TSB160088

New Intake and Exhaust Rocker Levers

Figure 2, New Exhaust Rocker Lever.

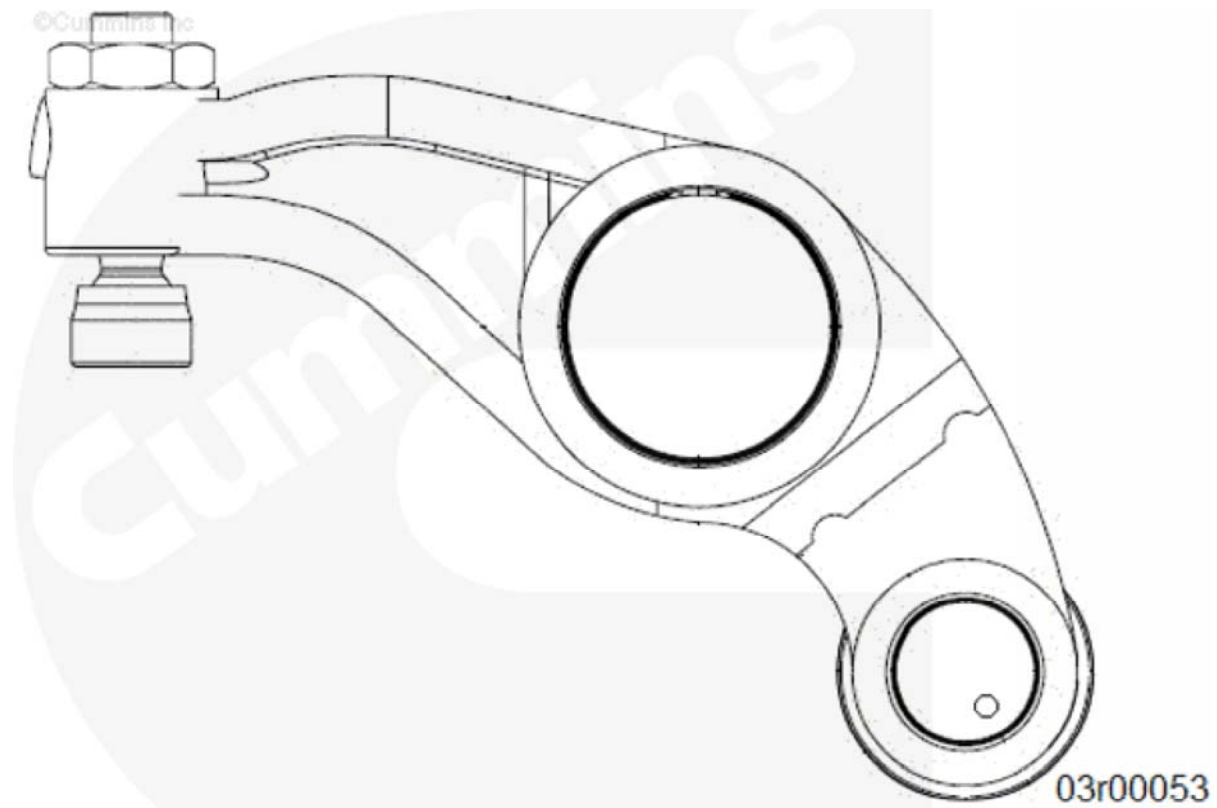
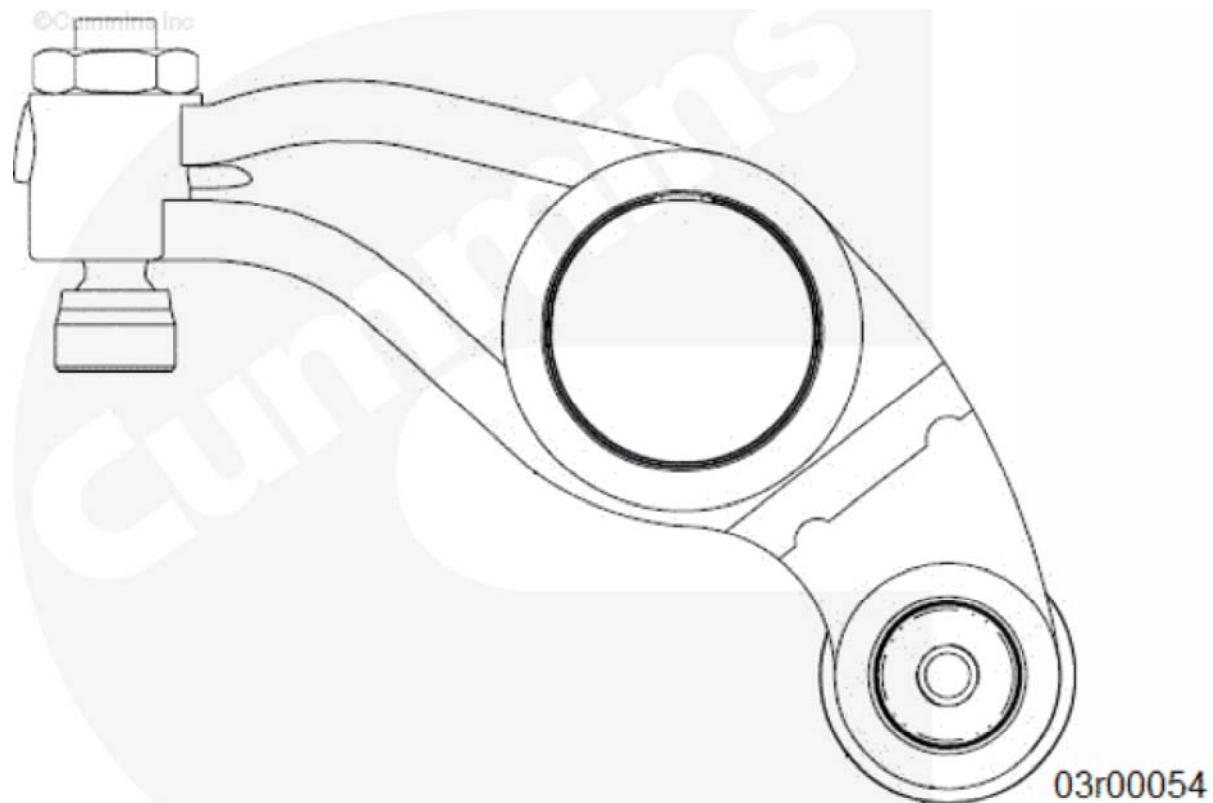
This document announces the release of new intake and exhaust rocker levers with lubricating oil feed and roller pin changes.

The changes to the roller pins and lubricating oil feed in the new rocker levers improve robustness against corrosion and debris related damage in the roller to roller pin joint.

New rocker levers can be distinguished by a roller pin which is black in color and hollow through the center. The existing rocker levers have a bronze colored solid pin. See Figures 1 and 2 below.

New and used rocker levers **must** be lubricated as directed in the Service Manual. Severe engine damage can result if rocker levers are **not** properly lubricated.

Lubrication of the roller pins has **always** been advised for rocker levers but emphasis is placed on this guidance as the result of lubricating oil feed changes on the new rocker levers. See the corresponding Service Manual. Reference Procedure 003-009 in Section 3.
